ITEM	PEX2022/0001 - 10-12 BOONDAH ROAD, WARRIEWOOD - PLANNING PROPOSAL
AUTHORISING MANAGER	MANAGER, STRATEGIC & PLACE PLANNING
TRIM FILE REF	2022/812548
ATTACHMENTS	1 NSW State Emergency Service (SES) Preliminary Advice 2 Submissions - Summary of Issues Raised

To report the assessment of a Planning Proposal for land at 10-12 Boondah Road, Warriewood and to recommend that the Panel advise Council to reject and not progress the Planning Proposal to a Gateway Determination.

Figure 2 - Flood Hazard Map

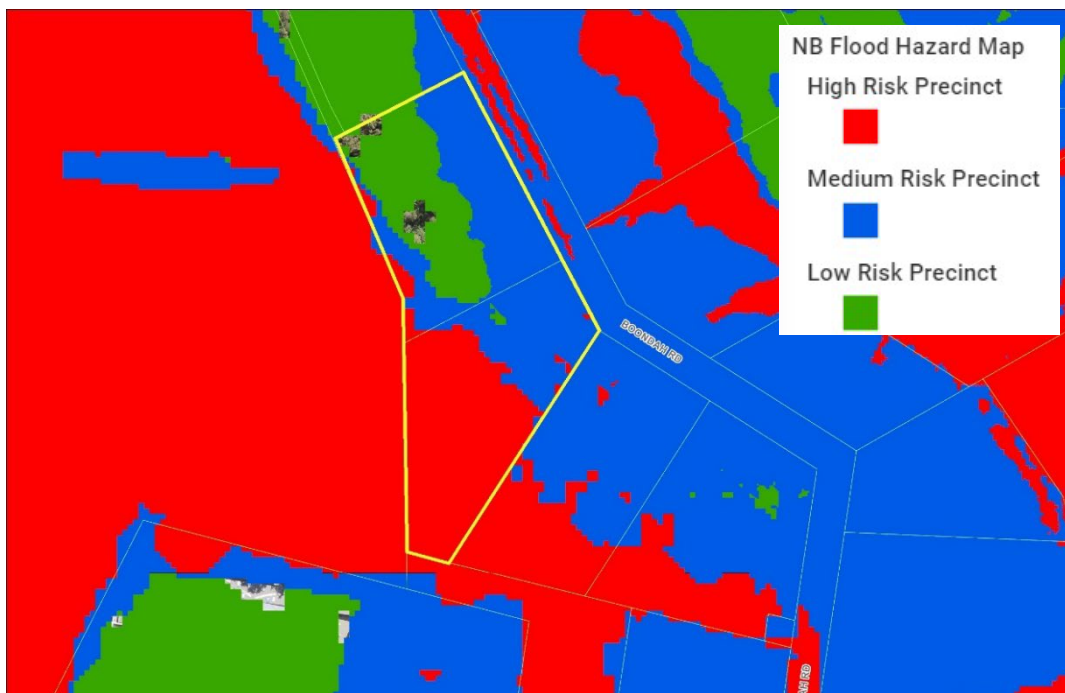
The site is in the Flood Planning Area. Council's Flood Hazard Map identifies High, Medium and Low Risk Precinct areas within the site (see Figure 2).

The Planning Proposal involves filling of most of the proposed R3 zoned land and the magnitude of filling is significant to meet required flood planning levels for the townhouses of RL4.4m, well above existing ground levels of around 2-4m AHD. Without adequate compensatory cut, this will result in a sizeable net loss of flood storage from the site which will need to be absorbed by other properties in the floodplain. The proponent has not demonstrated no net loss of flood storage. No volumetric calculations showing the proposed cut and fill balance have been provided. The proponent has instead focused on modelling to demonstrate no adverse impacts on surrounding properties and compliance with specific DCP controls for Warriewood Valley Release Area under C6.1.

Figure 4 - Extract of Site Plan prepared by Buchan Group

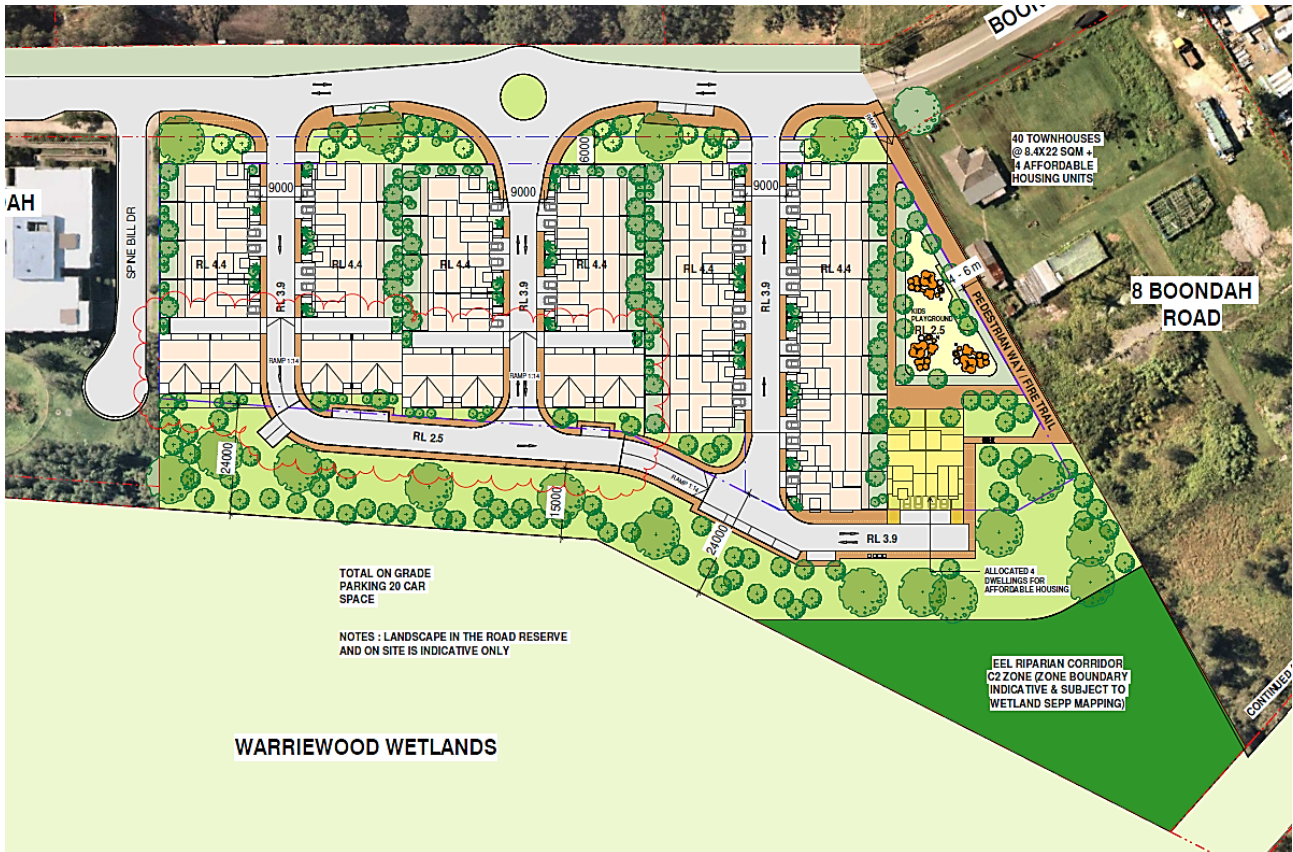
The Site Plan indicates a 6m setback of the proposed townhouses from Boondah Road, and a 24m wide bushfire asset protection zone (APZ) between the proposed townhouses and the boundary to the Warriewood Wetland, with roads, paths and parking located within the 24m wide APZ area.

The Planning Proposal fails to provide a 15m wide extensively landscaped buffer to protect the adjacent wetlands in accordance with clause 6.6 of the Pittwater DCP (DCP) due to management requirements of the overlapping bushfire Asset Protection Zone (APZ). In order to function as an effective ecological buffer to the wetland, the DCP requires a 15m buffer consisting of landscaped

mounds with mass planting of native trees and shrubs. The buffer should be exclusive of any APZ, and not overlap with it as is proposed. This is consistent with conditions of approval set by the PAC for the adjacent Meriton development, requiring a 25m wide APZ outside of a 10m wide Vegetated Wetland Buffer Zone and no excavation works in the Wetland Buffer Zone.

Figure 6 - Elevation to Boondah Rd, north end of site next to Meriton complex (extract Buchan Group report)

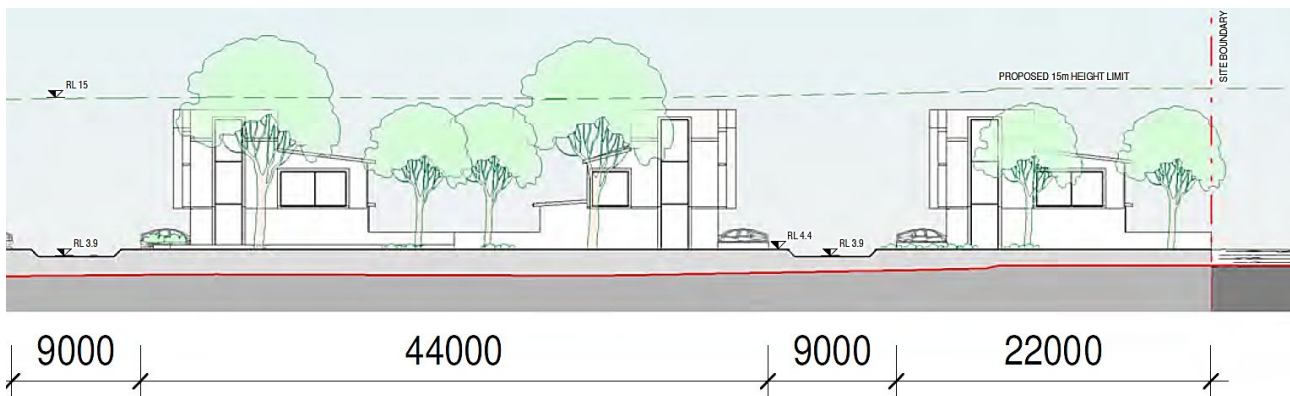
The proposed maximum building height of 15m is not sufficiently justified for the proposed 3-storey townhouses and could potentially enable a scale of built form out of character with the area. The applicant states the 15m height has been nominated to ensure that the earthworks required to raise the land to create building platforms above flood planning level and, once the site has been raised, the proposed dwellings do not result in a contravention of the height standard when measured from existing ground levels. No ground survey information has been submitted to indicate the maximum level of fill necessary for flood planning levels or to provide an accurate estimate of the maximum height of the proposed townhouses. The applicant has confirmed a willingness to accept an LEP control that limits the height of the buildings to 2 storeys plus attic, in addition to the proposed 15m height limit. The detail of this proposal has not been provided. The onus is on the applicant to propose appropriate LEP provisions and supply sufficient information to demonstrate that the provisions would result in buildings that are not of excessive scale and are in character with the area.

Figure 8 – Proposed Zoning

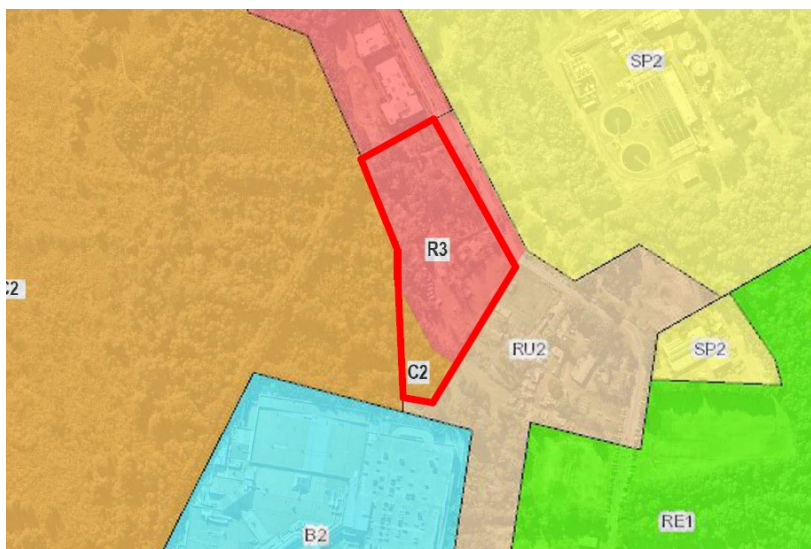
- while the applicant has stated that the proposed C2 zoning boundary encompasses all of the mapped Coastal Wetland under State Environmental Planning Policy (Resilience and Hazards) 2021, the proposal appears to include roads, earthworks, asset protection zones, bioretention basins, and stormwater filters and discharge points within the mapped Coastal Wetland areas;

- while the applicant has stated that the proposed C2 zoned land is intended to remain in private ownership under a Community Title scheme, without legal advice to indicate otherwise, there is a possibility that the C2 zoning could trigger an obligation for Council to acquire the land under the owner-initiated hardship provisions of the Land Acquisition (Just Terms Compensation) Act 1991, if the C2 zoning is deemed to be reserving the land for use for a public purpose. Despite enquiries made by Council planners, the NSW Department of Planning and Environment was unable to clarify the operation of the relevant legislation in this instance due to legal complexity;
